To : Product Compliance Office
From : Quality Control Department
Re : Product Status
Date : August 07, 2025
Reference no. : QCD-000-25-8-074
Cc. : PROD'N / PWD / SERVICE / SALES / DCO

Please be informed that the newly delivered Air Cooler, model KEA-50BLRDCA, has changes on some parts, and rated current printed on the name plate, under P/O number KT-2506VK-02. See attached photos for more details.

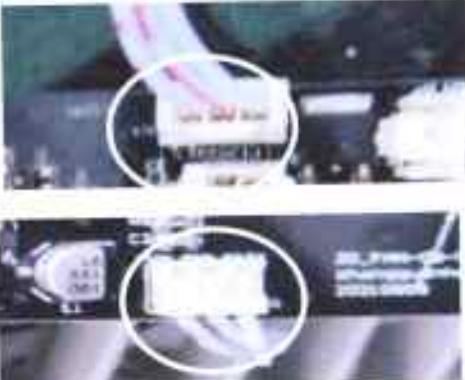
Remarks: The new PCB can also use to the previous unit, but the new main board are for new display board only, due to different connector to the previous board.
